ADDENDUM No. 7
Contractor for Controls Upgrade Project
M&T Bank Stadium
MSA Project No. 21-040

Date Issued: April 21, 2021

1. Questions and Answers.

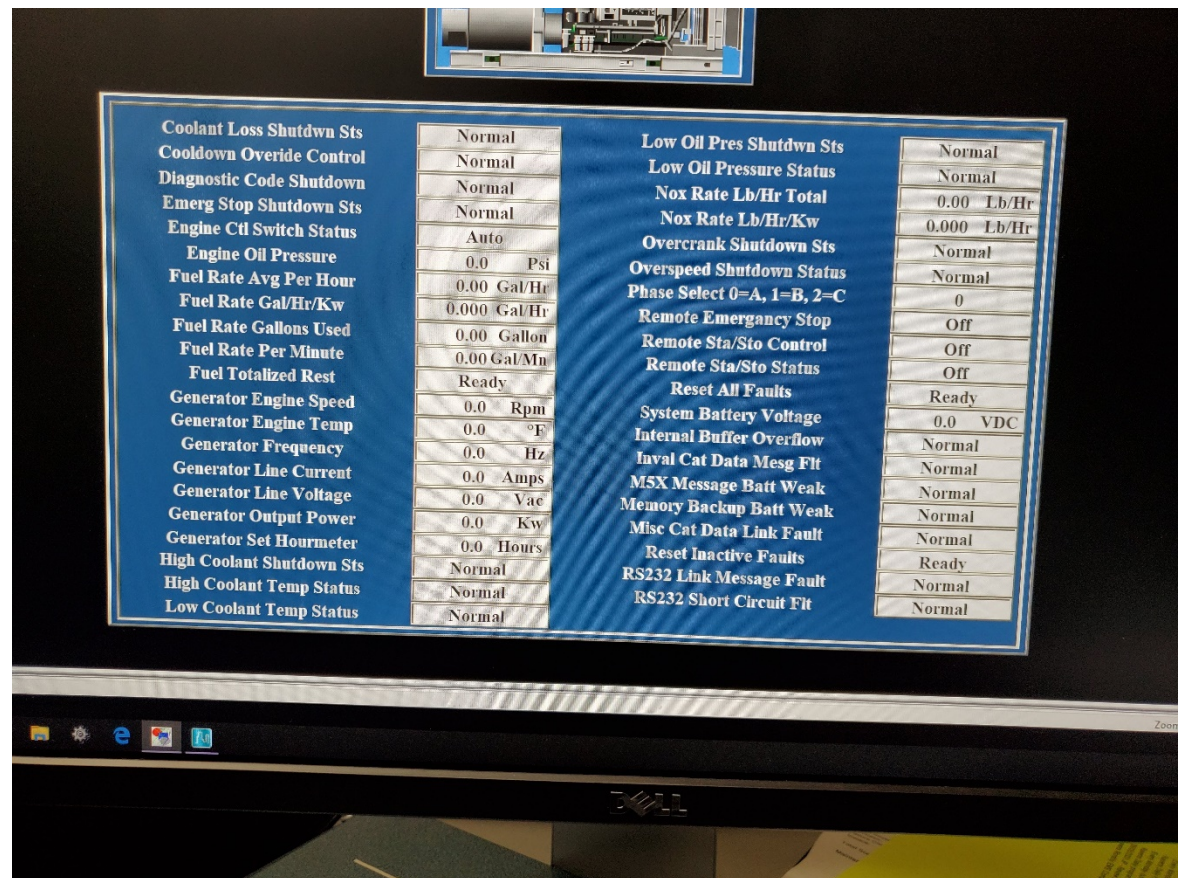
14. Specification 263213.13 – 5 2.4 E 3 calls for various alarm points to be monitored by the generator control system.

a) Are these alarm points currently available to the generator controls? For instance, is there currently a low-level alarm on the fuel main tank?

b) If possible, could an accounting of what points of this list are currently available and which need to be added please be provided to bidders.

RESPONSE: Some of the points currently exist, however, the Generator Controls are being replaced. Refer to points that are required. The existing 10,000 Gal Main Fuel Tank has an existing Veeder Root Fuel Monitoring System.

RESPONSE: See screen shots below of currently monitored points from the BAS.
